# Access Compliance Report

### (Curb Ramps)

| Intersection ID: 11164 | Main Street: CAMP_GREENE_ST | Cross Street: FREEDOM_DR | Location: S            |
| ADA ID: D98EDDC591F2   | Ramp Type: Perp             | Initial Pass/Fail: Fail  | Overall Compliance: No |

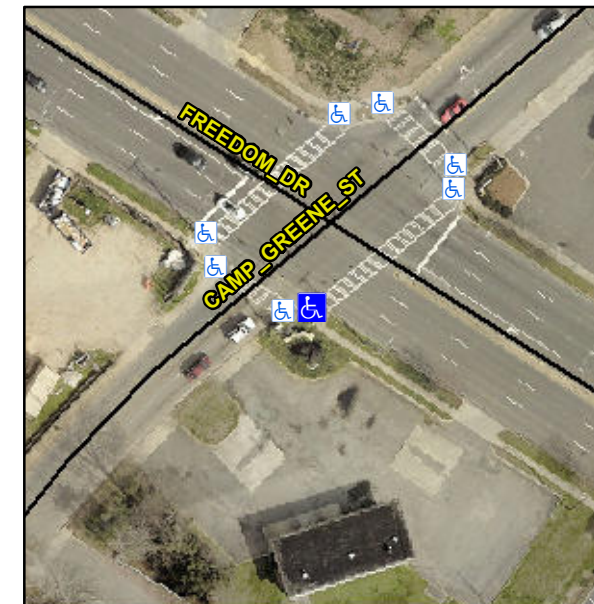
**R304.5.1**

| Compliance | Description           | Data  | Compliance | Description                 | Data |
|------------|-----------------------|-------|------------|-----------------------------|------|
| No         | Ramp Width (in)       | 47.0  | Yes        | Ramp XSlope (%)             | 0.3  |

**Remove & Replace Entire Ramp.**
